**HISTORIC LANDMARK COMMISSION
STAFF REPORT**

**PLNHLC2011-00296
Gutarra Residence Window Replacement
632 South 700 East
July 7, 2011**

Salt Lake Community Action Program, on behalf of property owner Carolina Gutarra, is requesting to replace five (5) existing windows on the south side of property located at 632 South 700 East, a single-family residence.

view from the south side windows will be replaced

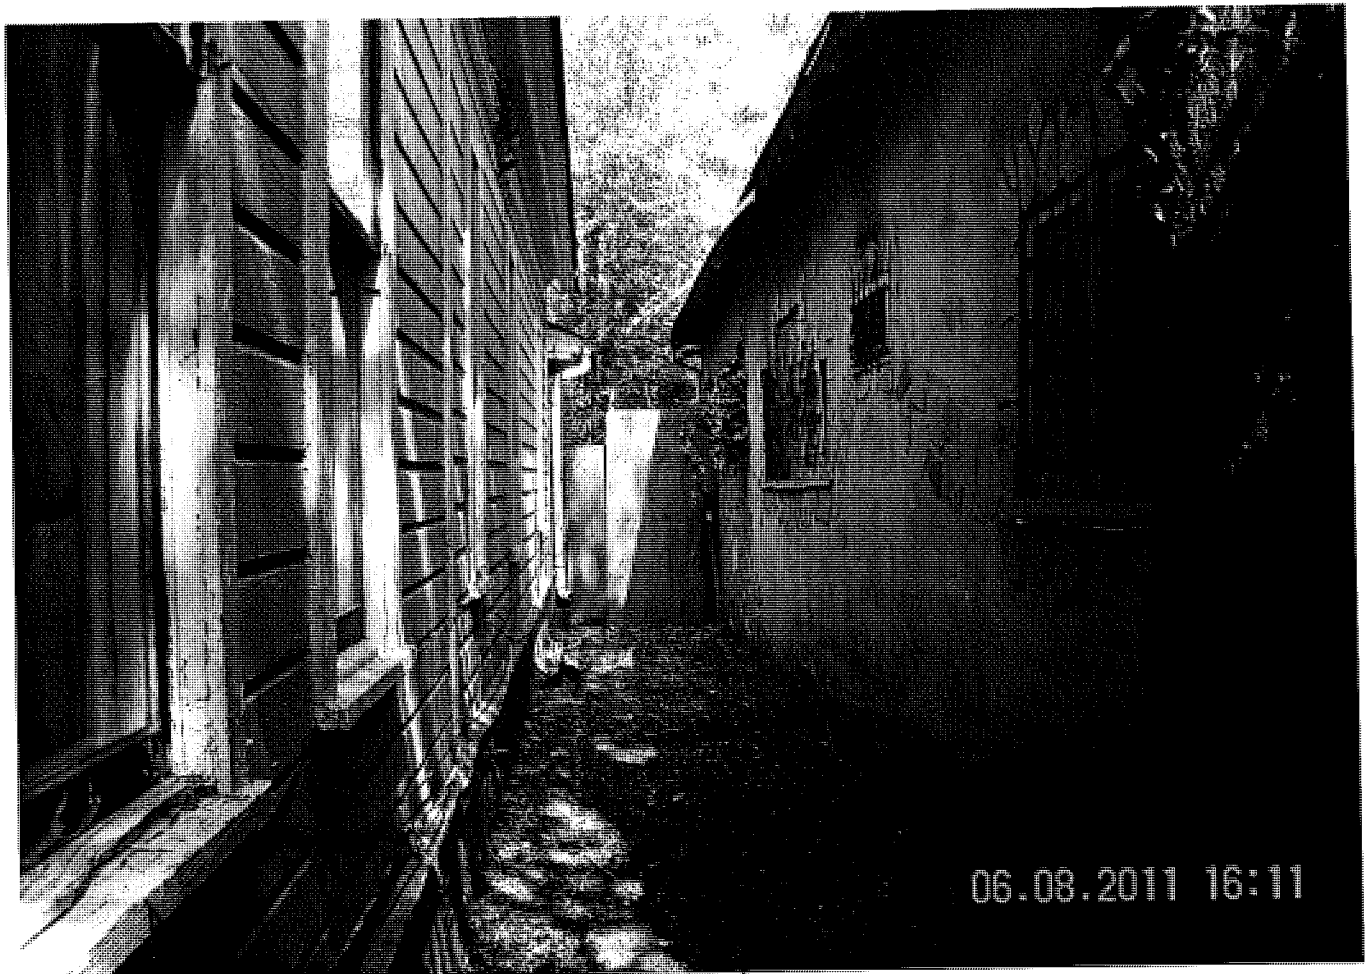
These windows are not visible from anywhere other than the neighbors house, (which is vacant and boarded up), therefore the adverse effect on the historic neighborhood will be minimum to none.

Subject Window #3

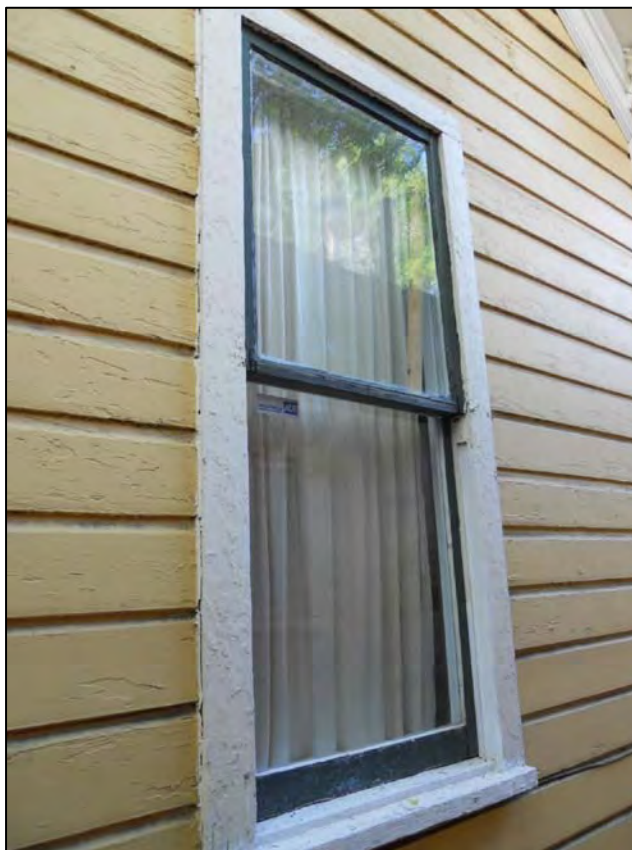
Analysis and Findings for Standard 6: SLCAP would prefer to replace the five (5) subject windows instead of repairing them. SLCAP believes the windows are “very loose and leaky” and that two (2) of the windows have wood “deteriorated in areas to make fixing them very difficult.” Staff found that while there was peeling paint and chipped wood on most of the frames, the wooden frames are sound. Staff believes other alternatives (re-caulking, weather stripping, thermal glazing or installing external/internal storm windows) should be explored before replacement is pursued.
